Three Mile Island Nuclear Station, Unit 1.  
Facility Operating License No. DPR-50  
NRC Docket No.50-289

**Subject:** Response to NRC Request for Additional Information related to Three Mile Island Nuclear Station, Unit 1, License Renewal Application

Response to Request for Additional Information for Time Limited Aging Analysis, Three Mile Island Nuclear Station, Unit 1, License Renewal Application.

Vertical Tendon Measured Forces, Trend and 95% LCL - 10 to 30 Years

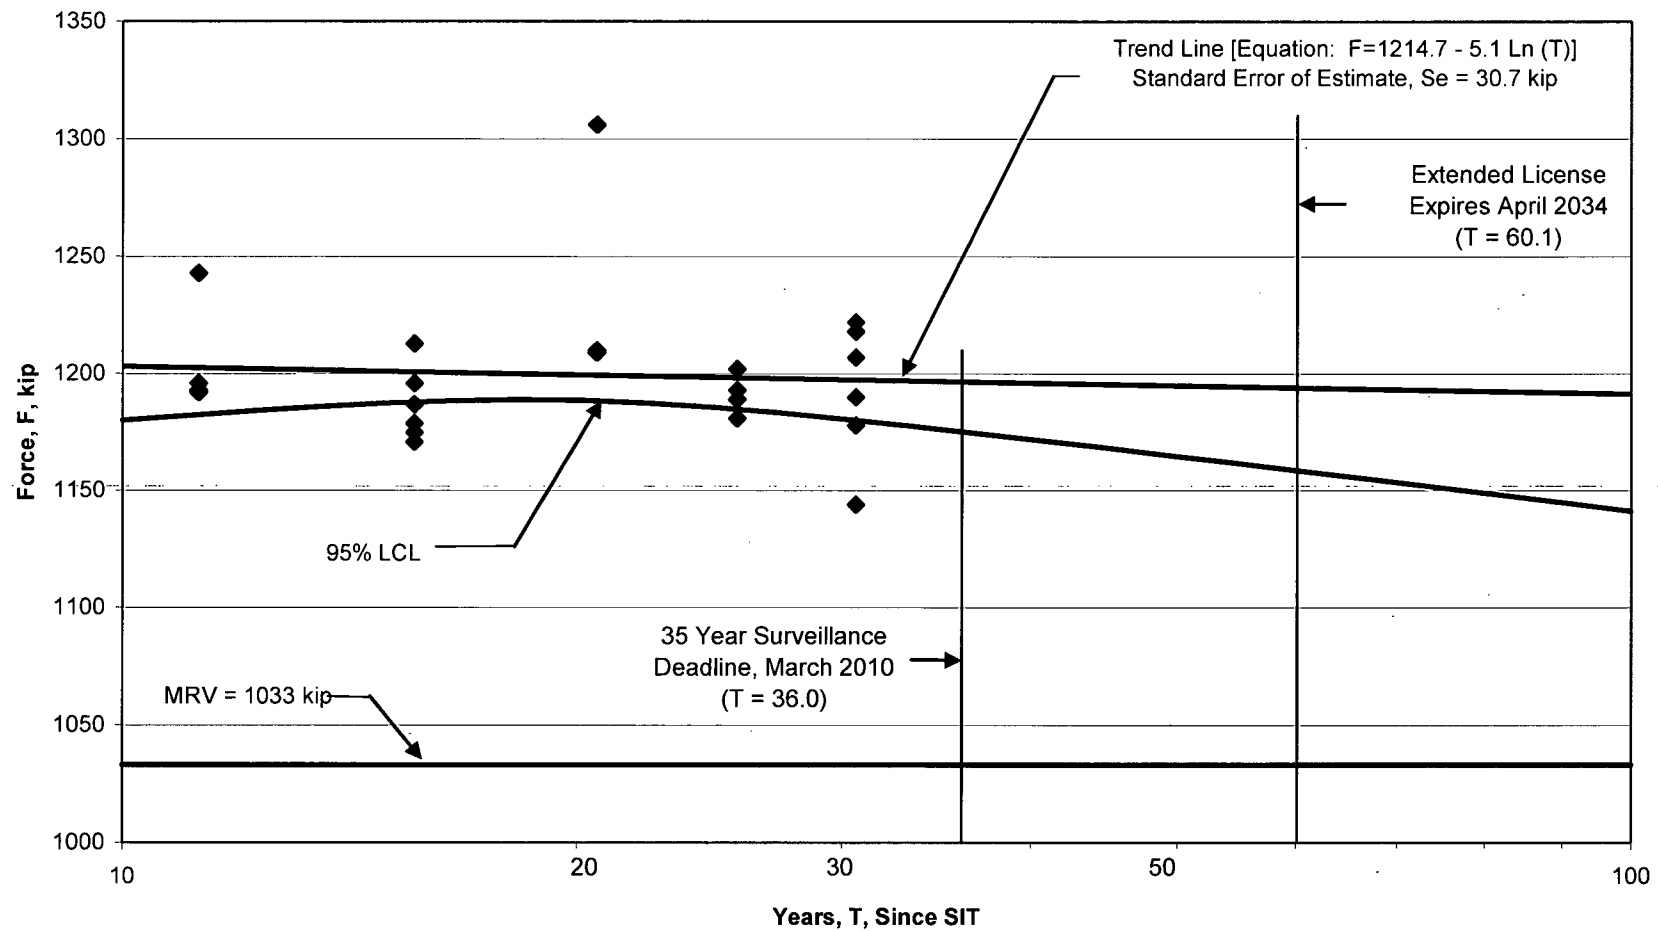
The plots or data for the historically inspected tendon forces, predicted forces, trend lines, and minimum required values (MRV) were not included in Section 4.7 of the LRA.

Provide log-year graphs of individual tendon forces versus 95% of the predicted force, and trend lines against MRV to confirm adequacy of the prestressing forces.

The log-year graphs reviewed and discussed with the reviewer during the AMP audit are shown as follows:

The first three graphs illustrate the individual measured tendon forces and MRV for each tendon group for vertical, hoop and dome. These graphs also indicate the measured tendon force trend lines and 95% lower confidence limit (LCL) projected through the period of extended operation.
